**Addendum No. 1
To the bid documents for: IFB #PLA 26-019
Hickory Trail Pedestrian Bridge Reconstruction**

Town of Amherst Response to Questions and Clarifications

Hickory Ridge Trails
Bridge Reconstruction
191 W. Pomeroy Lane

JOIST TO SILL PLATE CONNECTION DETAIL

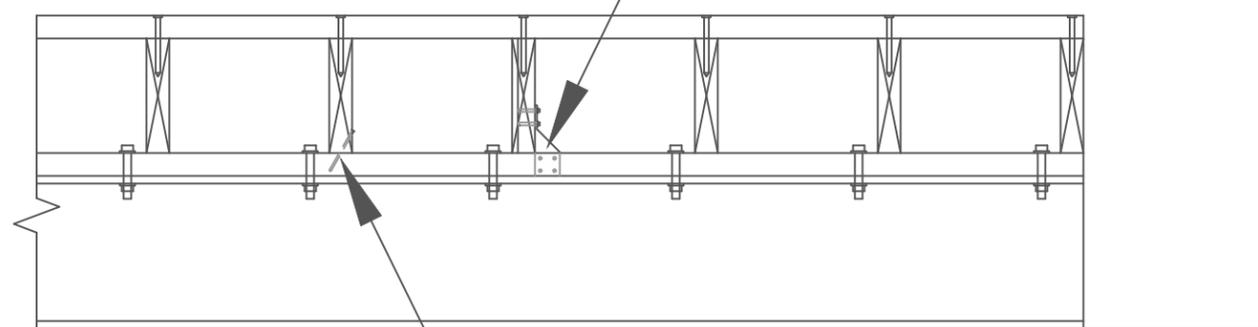
- Q9. Please provide a connection detail for the joists to the 2x6 sill.**
A9. See attached.
- Q10. Detail #2 calls out the framing to be 7 ½" a 2x8 is 7 ¼". Do you want larger dimensional lumber ripped to 7 ½" or is the standard 2x8 at 7 ¼" sufficient?**
A10. Standard 2x8 material measuring approximately 7-1/4" or 7-1/2" is sufficient.

- Q26. Please provide a detail for the connection between the 2x8 PT joists and the 2x6 PT sleeper plate.**
A26. See attached.
- Q27. Does the existing bridge contain any anchor bolts securing the steel beams to the concrete grade beam? If so, please provide the size.**
A27. No information is available.

4-5/8" 18 Gauge HDG Twist Tie. Install (1) Each End Every 4'-0" with HDG Screws

Install (3) HDG 10D Common Nail
